TOWN OF BAY HARBOR ISLANDS
QUASI-JUDICIAL PUBLIC HEARING
AGENDA
April 19, 2017

Subject: Site Development Plan Application - Revision
One Kane Concourse - Tauber Commercial / Office Building
9551 East Bay Harbor Drive
Revisions to 2011-12 Original Town Approval
Gateway District – Required Town Council Site Plan Approval
Bay Harbor Islands Acct. No. BP2016-88
MMPA Acct. No. 01-0702-946B

**Town Council Staff Report
One Kane Concourse / Tauber Commercial Development
9551 East Bay Harbor Drive
Site Development Plan Application – 2016-17 Revisions
February 24th, 2017
Page 2**

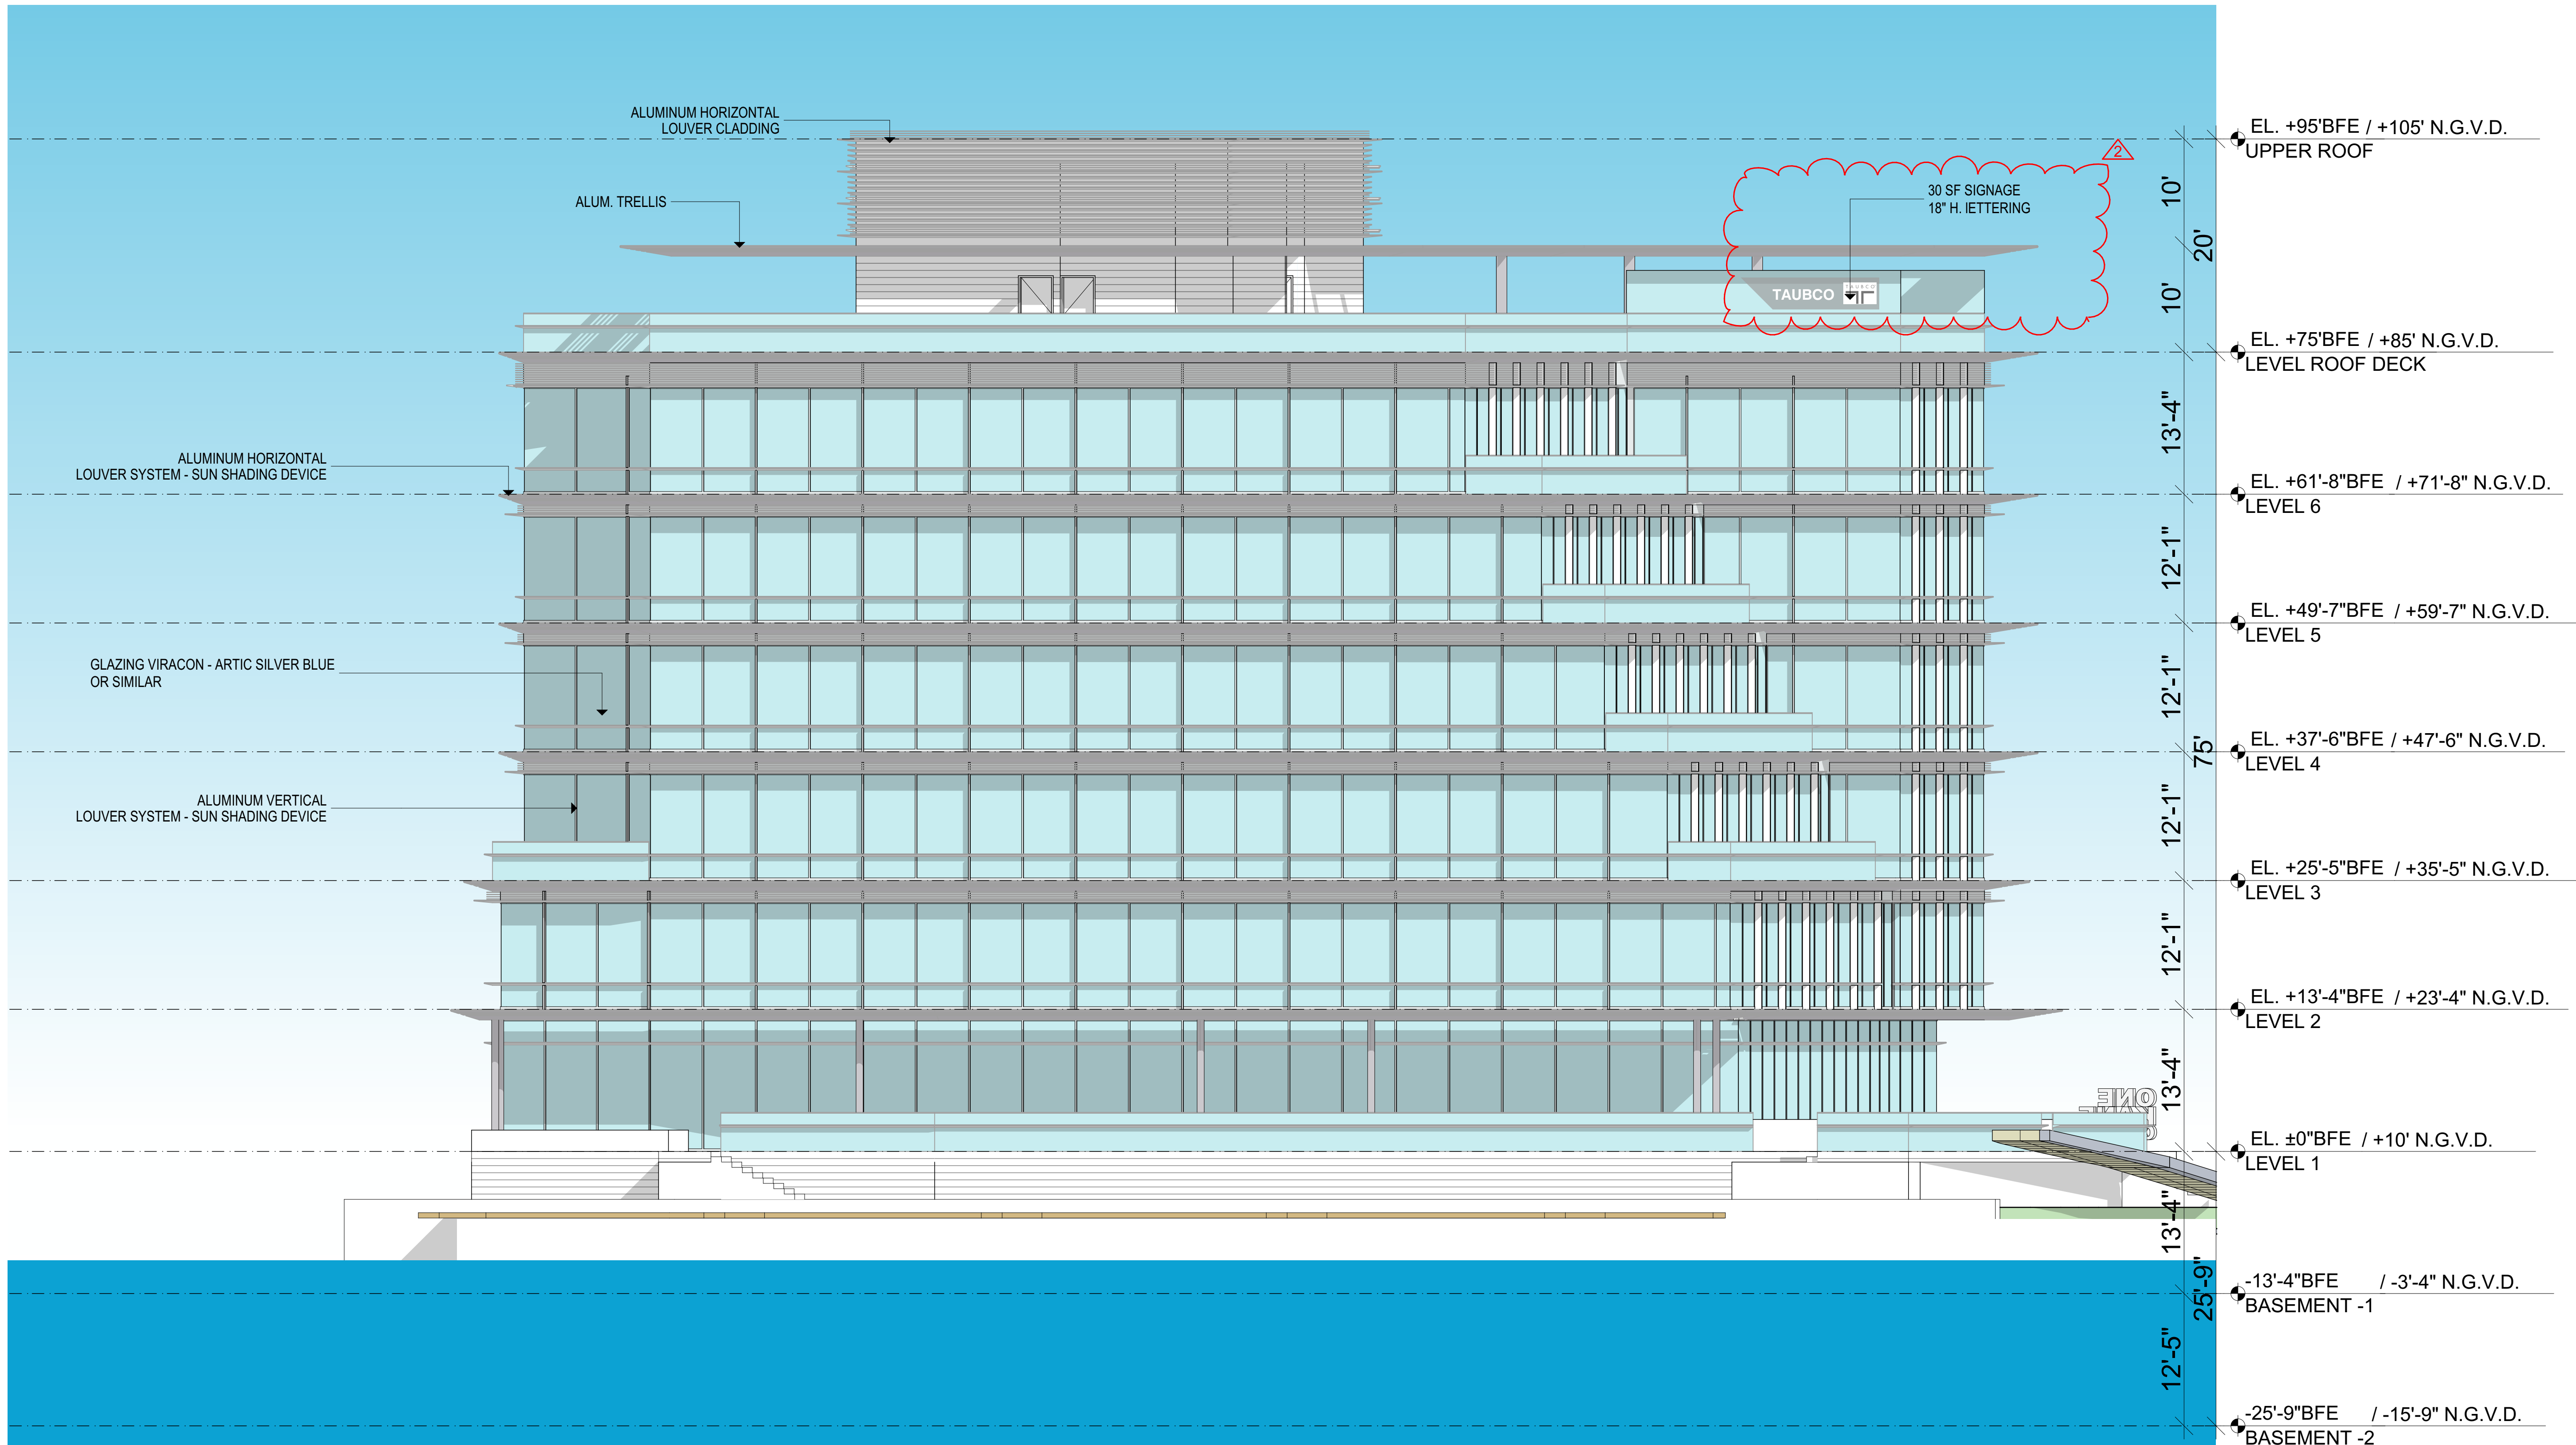
The building elevations are significantly different than the 2011 approved plans. For example, the new “flex” building massing facing Kane Concourse is proposed near the roadway intersection versus the waterfront. This changes the bulk massing appearance from Kane Concourse. The new architectural design has numerous vertical components on the building façade presenting a “busier” appearance, while the previous plan had long horizontal elements with few vertical architectural breaks giving a “softer” appearance. Also, the accessory rooftop structures (elevator shafts / stairs / bathrooms / mechanical rooms) are larger / taller than the 2011 design. These modified building design features should be considered carefully by the Town. The Code states the Town “may” approve flex building features if deemed acceptable (not mandatory).

- 3) MMPA notes that the building elevations are significantly different than the 2011 approved plans. For example, the new “flex” building massing facing Kane Concourse is proposed near the roadway intersection versus the waterfront. This changes the building massing appearance along Kane Concourse. The new architectural design has numerous vertical components on the building façade presenting a much “busier” appearance, while the previous plan had long horizontal elements with few vertical architectural breaks giving a “softer” appearance. The proposed accessory rooftop structures (elevator shafts / stairs / bathrooms / mechanical rooms) are larger / taller than the current design. MMPA does not normally comment on architectural design features, as that is primarily the purview of the PZB / TC; however, this is a community entranceway “Gateway” site, so extra design attention is warranted. The Town Code states the Town “may” approve certain building design features, such as building flex areas, if deemed acceptable.
